CERTIFICATE OF APPROPRIATENESS

Property: 1214 Harvard Street, Lot 16, Block 188, Houston Heights Subdivision. The property includes a historic 2,326 square foot, two-story wood frame single-family residence and a detached garage situated on a 6,600 square foot (50' x 132') interior lot.

Proposal: Alteration – Two-story side and rear addition to two-story house.

Recommendation: Denial - does not satisfy criteria 1, 4, 7, 8 & 9

NORTH SIDE ELEVATION

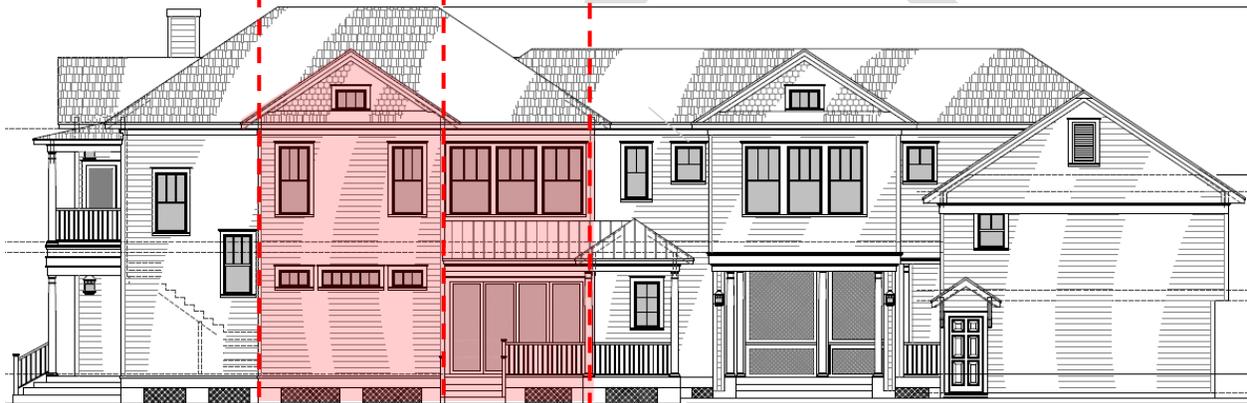
- (1) The proposed activity must retain and preserve the historical character of the property;
The existing residence is characterized by its relative narrowness compared to its height (27 ft wide and 34 ft tall), and by its simple rectangular footprint and hipped roof shape. In 1999, a sympathetic two-story rear addition added 13' and a rear porch to the structure, while maintaining the historic character of the house.
The applicant proposes to add a 6'-6" wide two-story side addition beginning just 15'-10" from the front wall that will be topped by a new cross gable, a change that will significantly alter the character of the house as seen from the right of way. This proposed south side addition will add only 200 sq ft of new livable space (100 sf on each floor), a small gain in contrast to the large adverse visual impact it will have on the house's historic character. Furthermore, the rear addition features a second story overhang on the north elevation of the existing house, which is also out of character for the house.

- (4) The proposed activity must preserve the distinguishing qualities or character of the building, structure, object or site and its environment;
The existing residence is characterized by its relative narrowness compared to its height. By beginning a two-story addition wider than the existing residence just 15'-10" from the front wall this distinguishing quality is eliminated. The house is also characterized by its simple rectangular footprint and hipped roof, which will be compromised with the south side bump out, the north side bump out 32' from the front wall and new cross-gable.

SOUTH SIDE ELEVATION

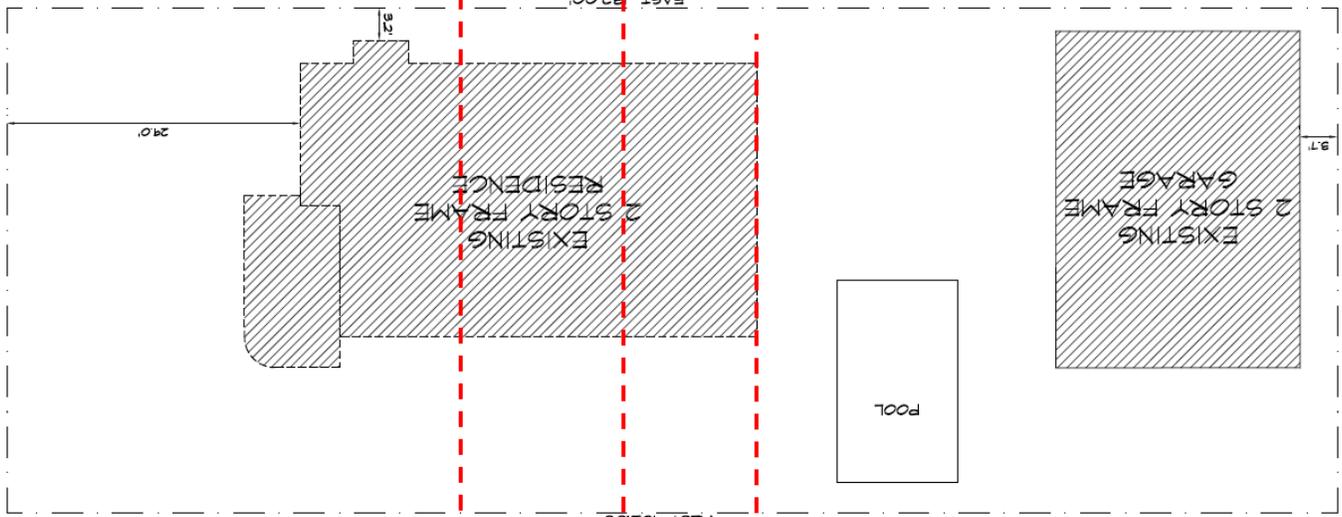
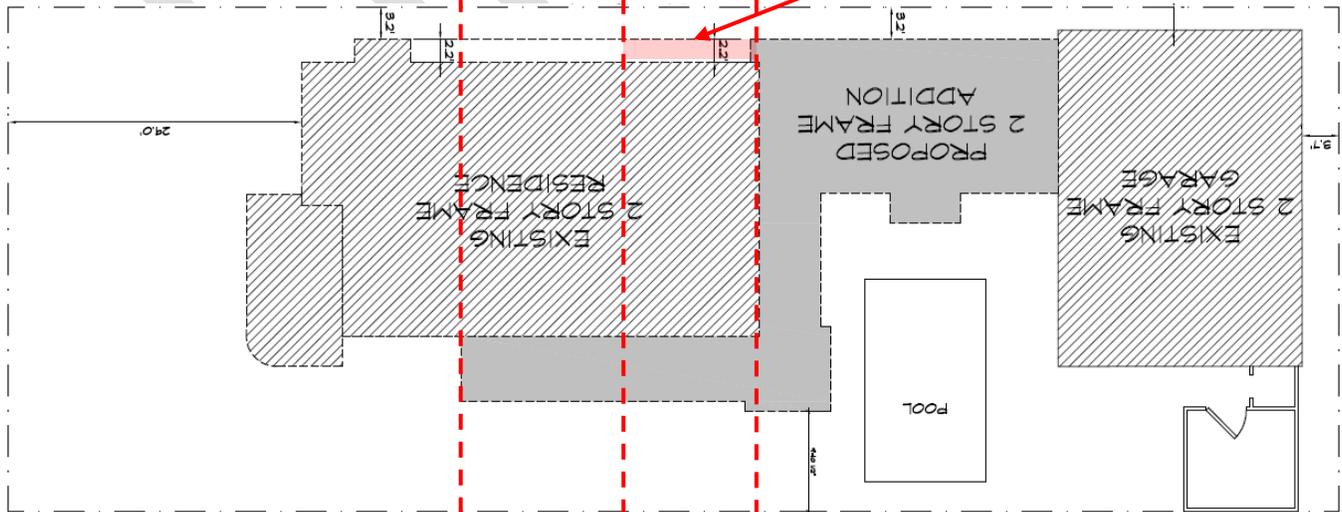
- (8) Proposed additions or alterations must be done in a manner that, if removed in the future, would leave unimpaired the essential form and integrity of the building, structure, object or site;
The proposed addition removes 28'-2" of the existing south wall, including 15'-10", or 57%, of the original 27' long south wall, and extends out on both sides, permanently removing a portion of the original exterior wall visible from the street as well as the distinctive narrowness and simple rectangular footprint of the structure. Although the existing siding and windows are not original, original window openings, wall structure, and the essential form of the south wall will be lost.

- (9) The proposed design for any exterior alterations or addition must not destroy significant historical, architectural or cultural material and must be compatible with the size, scale, material and character of the property and the area in which it is located;
*The proposed addition removes 15'-10", or 57%, of the original south wall. Although the existing siding and windows are not original, the original window openings and historic wall structure are intact.
Additionally, four window openings on the north wall, including two original window openings, are proposed to be removed and four new inappropriately proportioned window openings created. Many of the new windows will be 3/1 lite, although no evidence has been provided that this house originally had 3/1 windows, nor are 3/1 windows typical of Heights East. Additionally, 3/1 windows are found on Craftsman structures rather than Queen Anne style houses such as this one.
